# UNITED STATES PATENT AND TRADEMARK OFFICE

**Office Action Summary****Application No.**

10/578,122

## **DETAILED ACTION**

FIG. Z, as annotated by Examiner: return LNG vapor line to storage vessel on a ship

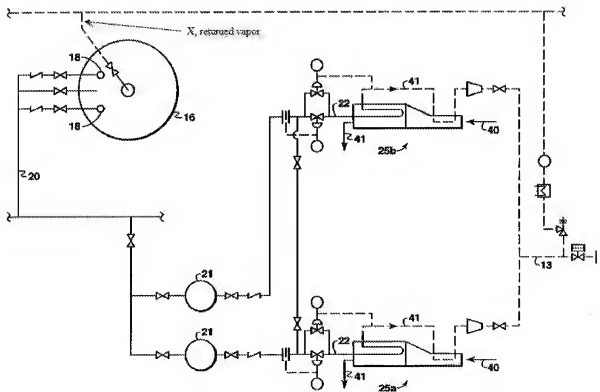
In reference to claim 6, Wilkinson and AAPA disclose the plant as described in the rejection of claim 1, but does not teach a second liquefied natural gas storage vessel that provides the liquefied natural gas and configured to provide a second liquefied natural gas vapor to the second liquefied natural gas storage vessel. Zednik shows a system (FIG. Z below, as annotated by the Examiner) wherein a portion of the liquid natural gas vapor (from the supply line 13, FIG. Z) is returned (via line X, FIG. Z) to the storage tank (16, FIG. Z) located off shore (10, FIG. Z) in order to replace the displaced volume from ship unloading.

In reference to claim 7, Wilkinson, AAPA and Zednik disclose the plant as described in the rejection of claim 1, but Wilkinson does not teach that the second liquefied natural gas storage vessel is located on a ship. Zednik shows a system (FIG. Z) wherein a portion of the liquid natural gas vapor (from the supply line 13, FIG. Z) is returned (via line X, FIG. Z) to the storage tank (16, FIG. Z) located on ship (10, FIG. Z; col 3, lines 65-66) in order to replace the displaced volume from ship unloading.
